Cawston Parish Council

Cawston Parish Council, Norfolk Boreas Offshore Wind Farm Inquiry, Deadline 13 submission.

Road deaths: GB, rolling years ending June, 2004-2019

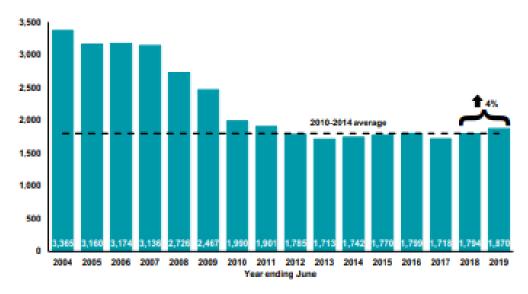
The Department of Transport's provisional estimates for reported road casualties in Great Britain, published in November 2019, are shown in the diagram above. The DoT concludes

Although there has been an increase in fatalities and decrease in total casualties in the year ending June 2019, these changes should be interpreted with caution. The increase in fatalities in the year ending June 2019 is likely to be natural variation around the longer term fat trend since 2010.

The DoT advises that changes in fatality or casualty figures, whether incremental, or exponential, should be interpreted with caution, calling into question the applicant's reasoning to reject using a fuller data set in drawing their conclusions on accident risk.
